<https://truckbodybuilder.scania.com>

January 16, 2026

Below you will find the latest information that is important to know when bodybuilding on a Scania vehicle.

## ALARM BODYWORK PREPARATION (FPC3661B) – IDENTIFIED HARNESS INSTALLATION ISSUE

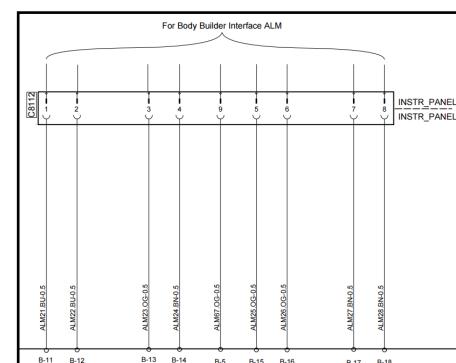
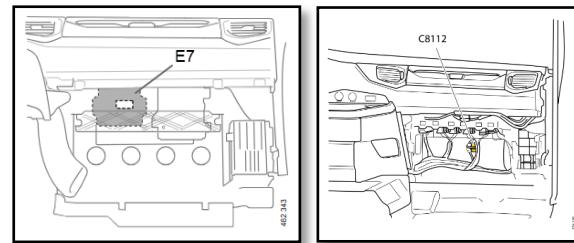
An issue has been identified regarding the cable harness preparation for the Alarm ECU on chassis equipped with Electrical System Generation 7 (SESAMM7 – FPC10149C).

Although vehicles are specified with FPC3661B Alarm bodywork preparation, the cable harness between the Alarm ECU (E7) and the harness-to-harness connector (C8112) is currently not mounted at the factory.

A permanent solution is initiated. Until then, vehicles specified with FPC10149C and FPC3661B will be delivered with the harness-to-harness connector C8112 installed in the Central Electric Unit in the instrument panel, but not connected to the Alarm ECU. Bodybuilders may then carry out the routing of nine wires with a cross-section of 0.5 mm<sup>2</sup> between connector C8112 and E7 connector B.
